TECHNICAL SPECIFICATIONS AFFECTED BY PROPOSED
AMENDMENT AND BRIEF DESCRIPTION OF CHANGE

NO SIGNIFICANT HAZARDS EVALUATION FOR CHANGES TO
TECHNICAL SPECIFICATIONS DELETING CERTAIN CYCLE-SPECIFIC PARAMETERS

Marked-Up Technical Specification Pages

Figure 3.1-2a

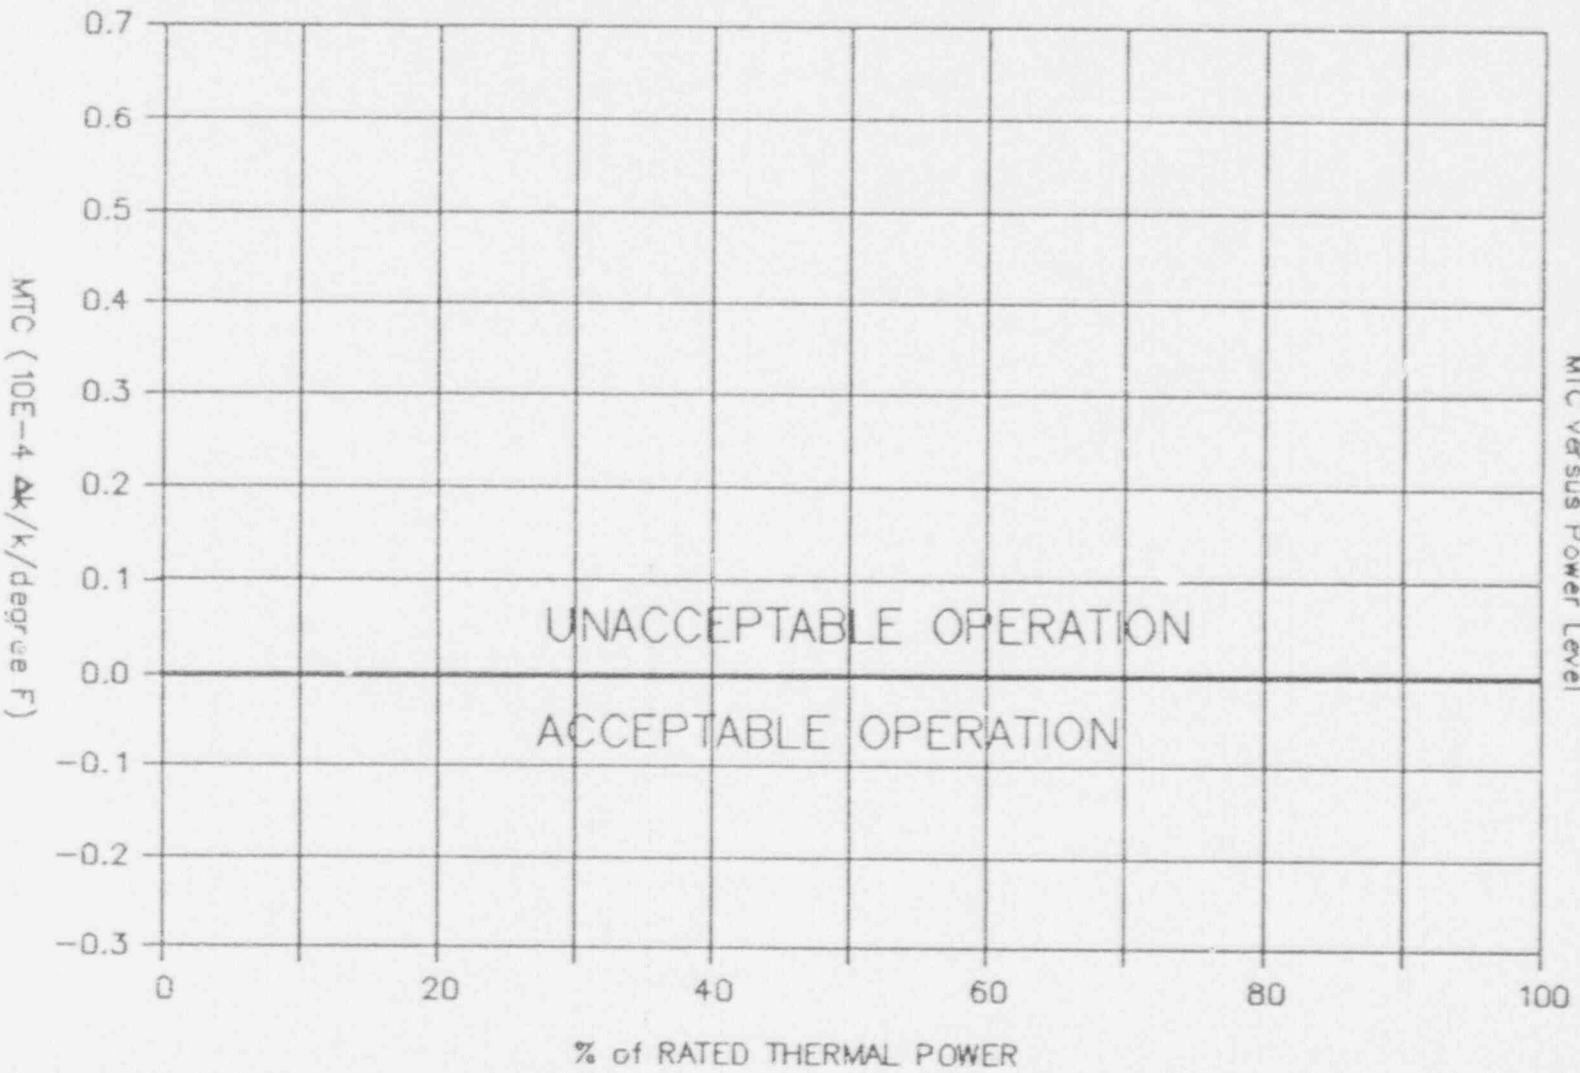
<u>PAGE</u>	<u>TECHNICAL SPECIFICATION</u>	<u>CHANGE DESCRIPTION</u>
3/4 1-6	3.1.1.1 Moderator Temperature Coefficient	Relocates MTC Limits to the COLR and corrects references
3/4 1-7	4.1.1.3 MTC Surveillance Requirement	Relocates MTC Limits to the COLR and corrects references
3/4 1-7a	New Figure 3.1-2a, Maximum MTC Limit Curve, MCT vs Power Level. Page added to Tech Specs to accommodate it.	Retains upper MTC Limit. Required for positive MTC Spec (future possibility). Figure is also in COLR for T. S. 3.1.1.3
B3/4 1-2	3/4.1.1.3 Moderator Temperature Coefficient Bases	Administrative Change. MTC Limits have been relocated to the the COLR.
3/4 1-16	3.1.3.1.b.2 Movable Control Assemblies-Group Height	Administrative change. Removes reference to Figure 3.1-3, removed to the COLR in a previous amendment
3/4 1-17	3.1.3.1.c.1 Movable Control Assemblies-Group Height	Administrative change. Removes reference to figure 3.1-3, removed to the COLR in a previous amendment.

- 3.1.1.3 The moderator temperature coefficient (MTC) shall be within the limits specified in the Core Operating Limit Report (COLR). The maximum upper limit shall be less than or equal to
- a. ~~Less positive than $0 \Delta k/k/^\circ F$ for the all rods withdrawn, beginning to that shown of cycle life (BOL), hot zero THERMAL POWER condition; and~~ in Figure 3.1-2a
 - b. ~~Less negative than $-4.0 \times 10^{-4} \Delta k/k/^\circ F$ for the all rods withdrawn, end of cycle life (EOL), RATED THERMAL POWER condition.~~

the 300 ppm surveillance limit specified in the COLR

FIGURE 3.2-1

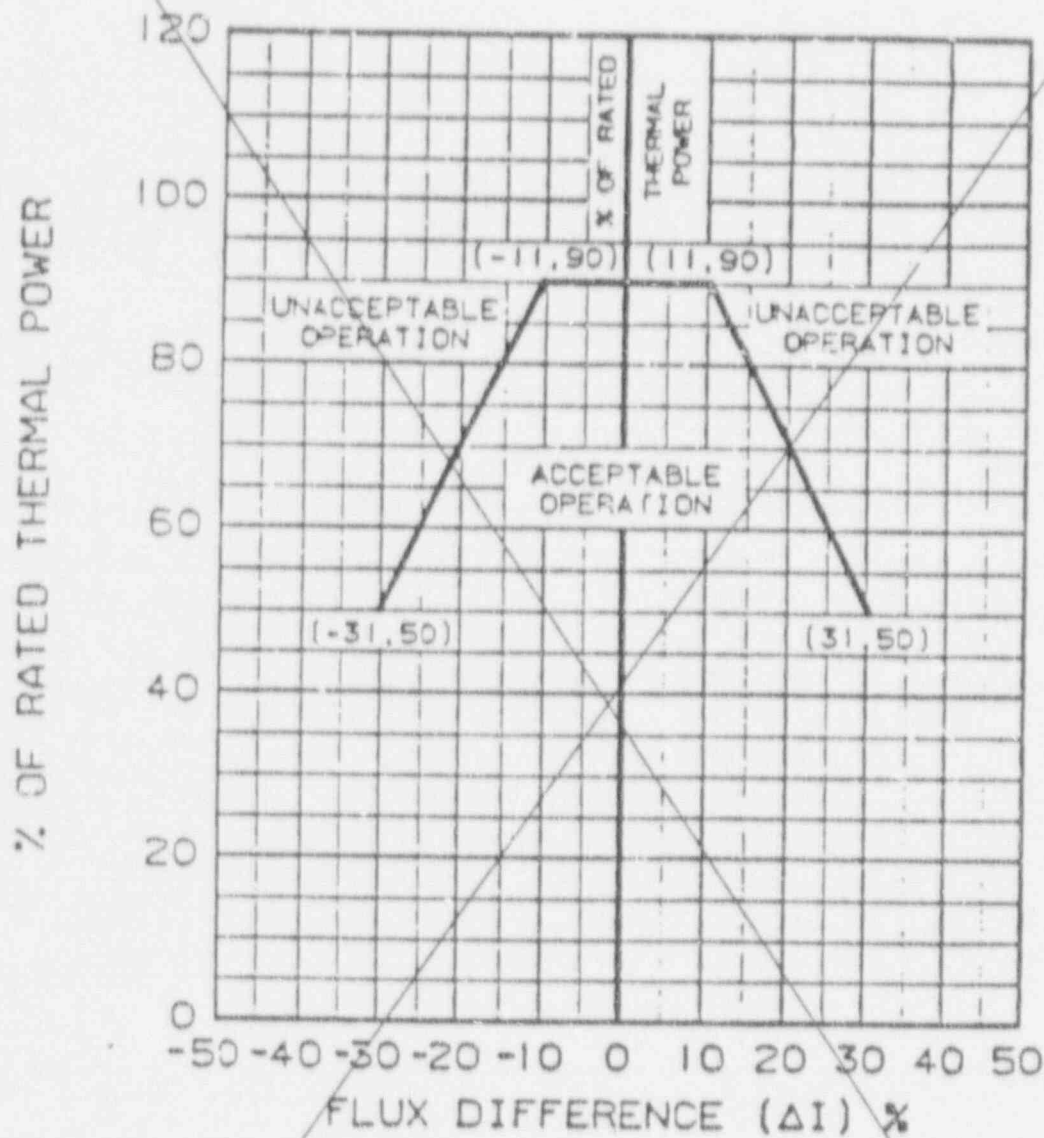
3/4 1-22	3.1.3.5 Shutdown Rod Insertion Limit	Administrative change. Clarifies that the fully withdrawn position for shutdown banks is specified in the COLR.
3/4 2-1	3.2.1.b Axial Flux Difference	Replaces references to Figure 3.2-1, which is moved to the COLR
3/4 2-2	3.2.1.C Axial Flux Difference	Deletes the word "above" twice in reference to Figure 3.2-1,
3/4 2-4	Figure 3.2-1 BLANK	Figure moved to the COLR
B3/4 2-1	3/4.2.1 Axial Flux Difference Bases	Administrative change. The F_0 Limit is removed to the COLR
B3/4 2-2	3/4.2.1 Axial Flux Difference Bases	Removes reference to Figure 3.2-1, Figure 3.2-1 removed to the COLR

The indicated AFD may deviate outside the above required target band at greater than or equal to 50% but less than 90% of RATED THERMAL POWER provided the indicated AFD is within the Acceptable Operation Limits of ~~Figure 3.2-1~~ and the cumulative penalty deviation time does not exceed 1 hour during the previous 24 hours. *specified in the COLR*

b. With the indicated AFD outside of the above required target band for more than 1 hour of cumulative penalty deviation time during the previous 24 hours or outside the Acceptable Operation Limits of ~~Figure 3.2-1~~ and with THERMAL POWER less than 90% but equal to or greater than 50% of RATED THERMAL POWER, reduce:

Deleted

FIGURE 3.2-2

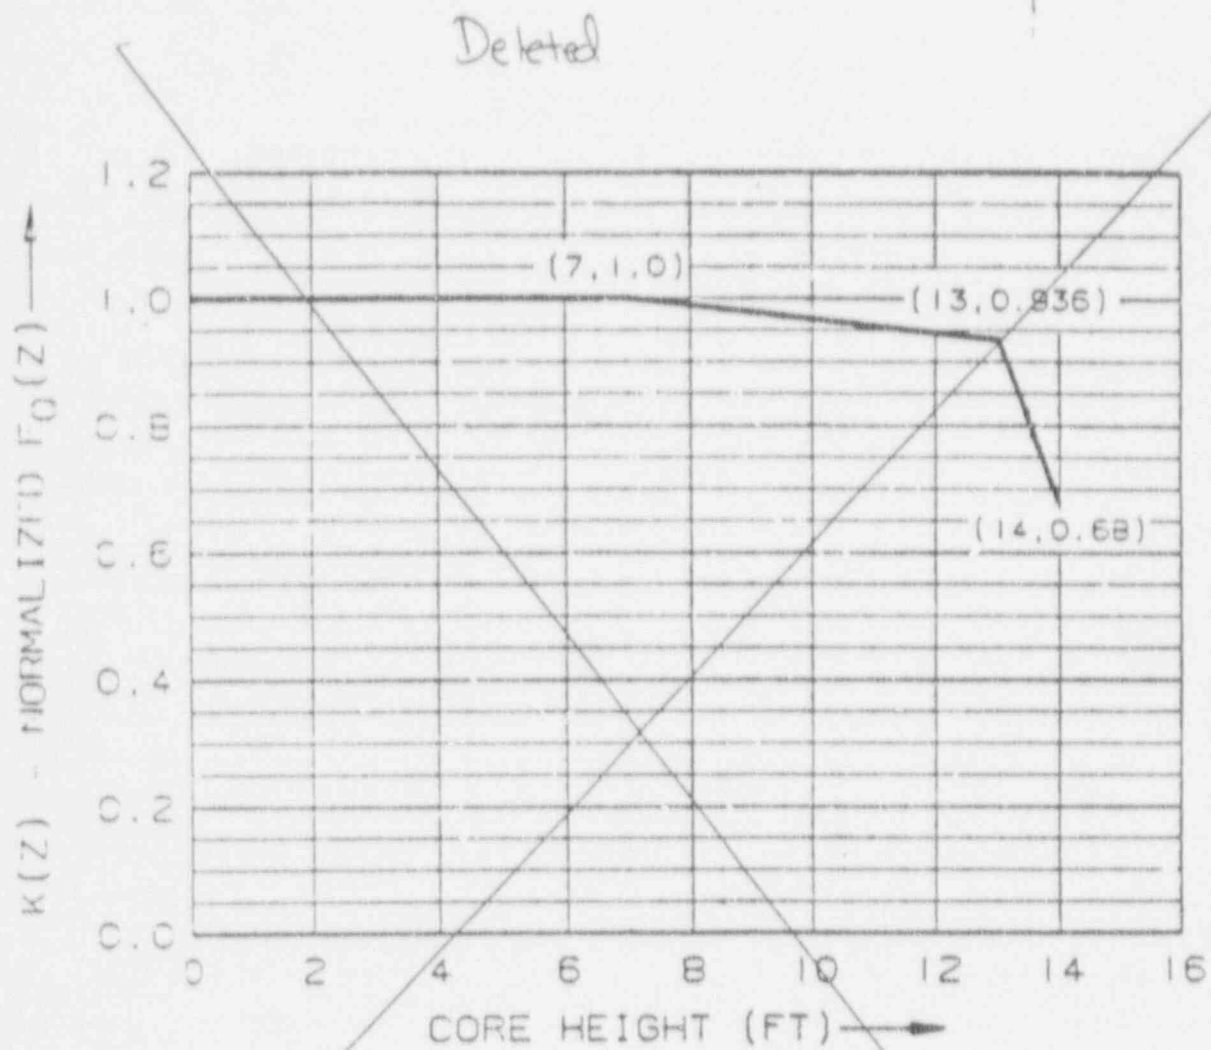
<u>PAGE</u>	<u>TECHNICAL SPECIFICATION</u>	<u>CHANGE DESCRIPTION</u>
3/4 2-5	3.2.2 Heat Flux Hot Channel Factor	Relocates the F_0 and $K(Z)$ to the COLR. The numerical F_0 limit is replaced with a function F_0^{RTP} , which is to be specified in the COLR
3/4 2-6	Figure 3.2-2 BLANK	Figure moved to the COLR
3/4 2-7	4.2.2.2.C.2 Heat Flux Hot Channel Factor Surveillance Requirements	Replaces the numerical part power multiplier for F_{xy} with a function PF_{xy} , which will be specified in the COLR
3/4 2-8	4.2.2.2.e Heat Flux Hot Channel Factor Surveillance Requirements	Administrative Change The Radial Peaking Factor Limits Report was replaced by the COLR in a previous amendment
B3/4 2-5	3/4.2.2 and 3/4.2.3 Heat Flux Hot Channel Factor and Nuclear Enthalpy Rise Hot Channel Factor Bases	Administrative change. The Radial Peaking Factor Limits Report was replaced by the COLR in a previous amendment
3/4 2-9	3.2.3 Nuclear Enthalpy Rise Hot Channel Factor	Relocates the F_{DH} to the COLR. The numerical values for the F_{DH} limit and the part power multiplier are replaced with parameters F_{DH}^{RTP} , and PF_{DH} , which are to be defined in the COLR

$K(Z)$ = the function obtained from Figure 3.2-2 for a given
core height location;

normalized $F_Q(Z)$ as a function of
specified in the 3.2.
